Access Compliance Report

Public Rights-of-Way

(Curb Ramps)

Intersection ID: 18350	Main Street: PROVIDENCE_RD	Cross Street: SHARON_LN	Location:	E
ADA ID: 66405FE38484	Ramp Type: BlendTrans1	Initial Pass/Fail: Fail	Overall Compliance: No	Severity Score: 10
Codes/Mitigation Info/Possible Solution		Field Measurements/Component Compliance

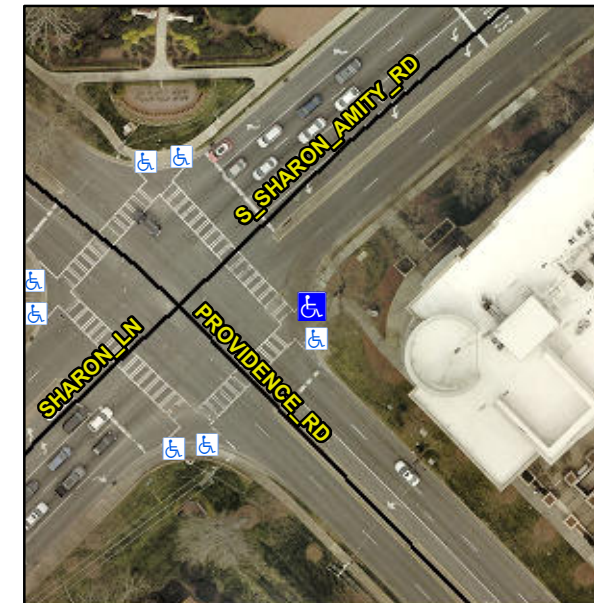
Not Found, R304.5.1, R304.5.3

Compliance	Description	Data	Compliance	Description	Data
N/A	Ramp Length (in)	59.0	Yes	BlendTrans Slope (%)	1.7
No	Ramp Width (in)	45.5	No	BlendTrans XSlope (%)	2.6
N/A	Flare Type LT	N/A	N/A	Flare Type RT	N/A
N/A	Flare Slope LT (%)	N/A	N/A	Flare Slope RT (%)	N/A
N/A	Flare Traversable LT?	N/A	N/A	Flare Traversable RT?	N/A
N/A	Landing Length (in)	N/A	N/A	DWS Provided?	N/A
N/A	Landing Width (in)	N/A	N/A	DWS Contrast?	N/A
N/A	Landing Slope (%)	N/A	N/A	DWS Length (in)	N/A
N/A	Landing X Slope (%)	N/A	N/A	DWS Full Width?	N/A
N/A	Landing Curb? (Y/N)	N/A	N/A	DWS Offset (in)	N/A
N/A	Shared Landing?	N/A			
N/A	Gutter Ponding?	N/A	N/A	Gutter Slope (%)	N/A
N/A	Gutter Lip Ht (in)	N/A	N/A	Gutter X Slope (%)	N/A
N/A	Painted X Walk1?	Yes	N/A	Painted X Walk2?	N/A
	X Walk 1 Direction	To SW		X Walk 2 Direction	N/A
	X Walk 1 Width (in)	105.0		X Walk 2 Width (in)	N/A
	X Walk 1 Slope (%)	1.8		X Walk 2 Slope (%)	N/A
	X Walk 1 X Slope (%)	1.3		X Walk 2 X Slope (%)	N/A

N/A	Ramp inside XWalk1?	No	N/A	Ramp inside XWalk2?	N/A
	Road Slope (%)	1.3		Clear Space?	N/A
	Road X Slope (%)	1.8	N/A	Clear Space to XWalk (in)	N/A
N/A	Any Obstructions?	N/A	N/A	Storm Grate/Utility Hazard?	N/A
	Obstruction Type			Storm Grate/Utility Type	
		N/A			N/A
			Yes	Surface Condition? (G/P)	Good
			No	Curb Slope (%)	11.6

Remove & Replace Curb Ramp With Two New Directional Ramps or Equivalent. Restripe Crosswalk.
